04-0120F4  
 04-SF-80-12.6/13.2  
 San Francisco Oakland Bay Bridge  
 Self Anchored Suspension Span

REPORT NO.	851	to	857	DATE	Apr 12 – Apr. 18, 2009	S T W Th F S
SHIFT HOUR	START	Var.	STOP	Var.	TEMPERATURE	
WEATHER	Sunday Monday – Tuesday – Wednesday – Thursday – Friday -Saturday –

SUB915, SHEET E5-SB10

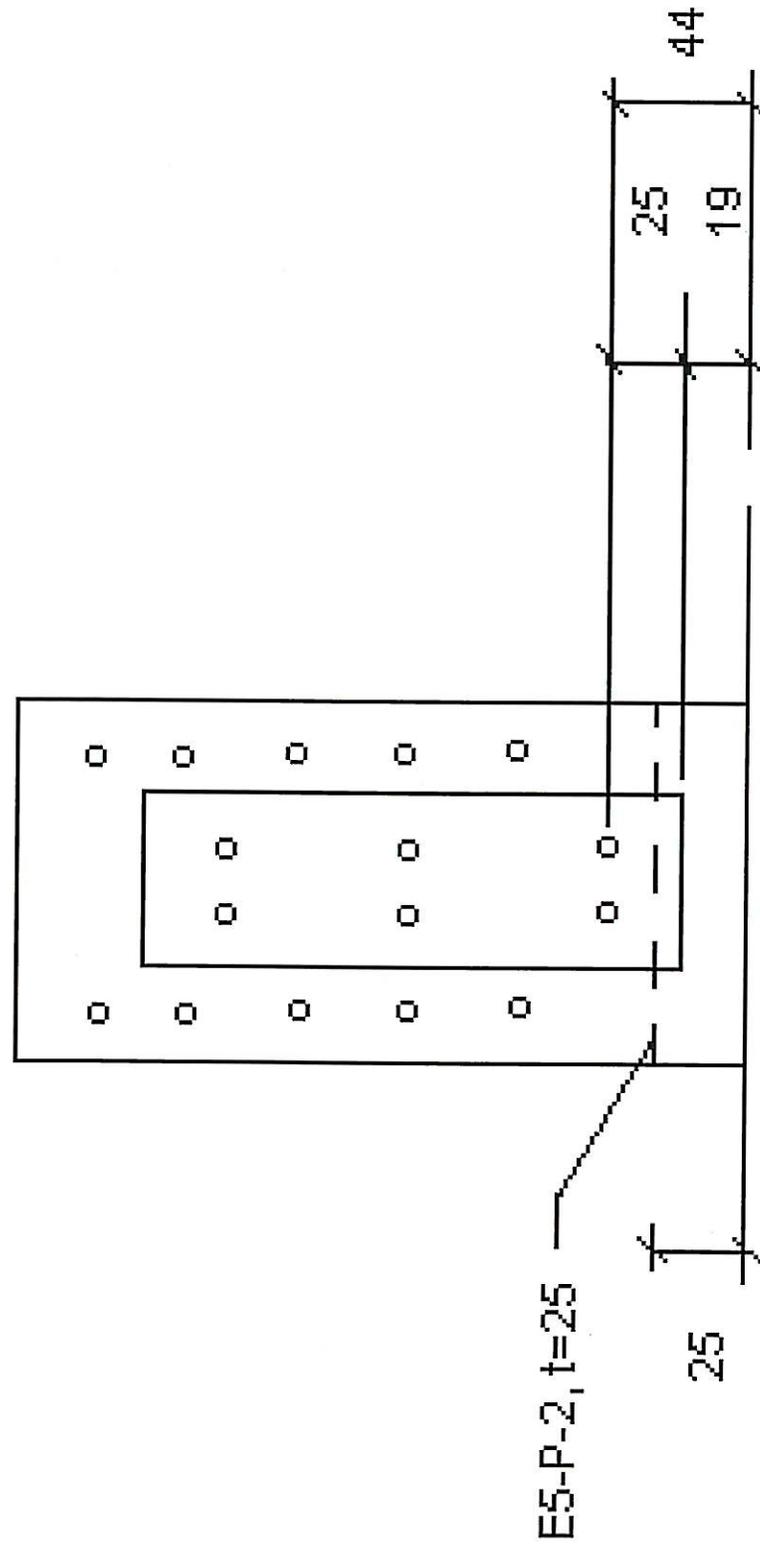
To explain some of what we discussed yesterday, Plate E5-P-11b stands somewhat inclined against the OBG Deck plate. Just behind this plate at Section G-G and inside the Steel Barrier consist of a Diaphragm that stands vertically on a 25mm thick plate (E5-P-2). This plate stretches at a length of 200mm. However, the dotted lines in E5-SB10 Elevation view represents a series of plates with the same thickness (25mm) along the steel barrier. I hope this clarifies any confusion.
